Delegated Report

Householder Planning Application

Application No:	20221211
Location:	180 Singlewell Road, Gravesend, Kent, DA11 7RB
Description:	Alterations to existing driveway to create an additional entrance/exit with a second dropped kerb.
Applicant:	Margaret Beighton
Site Visit:	N/A Desktop Assessment

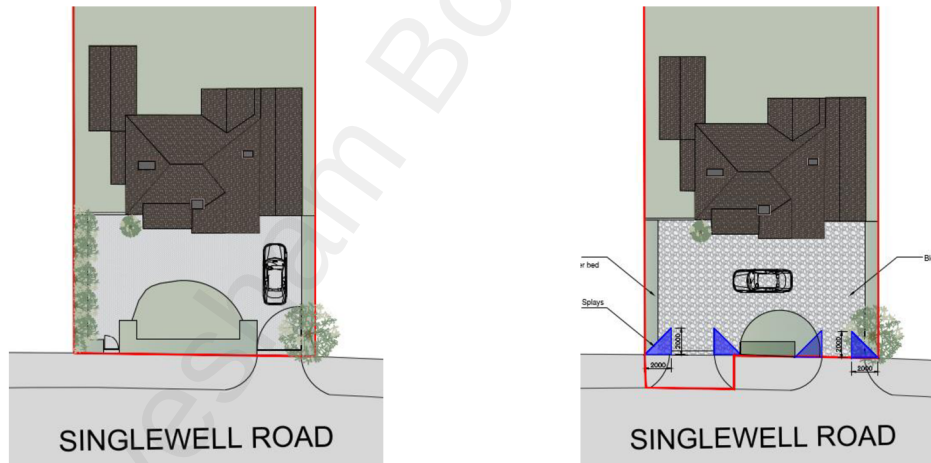
This application proposes the creation of a second gated vehicular access. The existing pedestrian access would be replaced by an additional vehicular access and dropped kerb, to create an entrance/exit driveway. The soft landscaped section on the frontage would be reduced as part of this development, as shown in the block plans below:

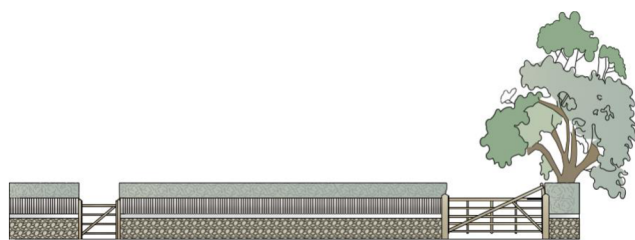
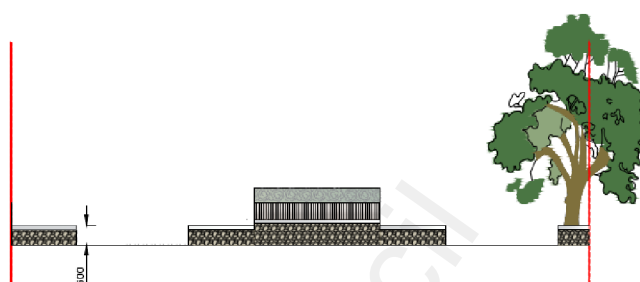
The proposed development will alter the appearance of the property's frontage. The existing pedestrian access will be widened and replaced by a larger opening for vehicles, with the existing vehicular access widened to mirror the new access (as shown in the comparison screenshots below):

The central hedgerow and lawn behind will be reduced but importantly retained, which ensures some of the existing character is retained and limits the impact on the street scene. The driveway will be block paved and the mature tree will be retained. Overall, the development is in accordance with Policy CS19 (LPCS) and Section 12 of the National Planning Policy Framework (NPPF) (2021).
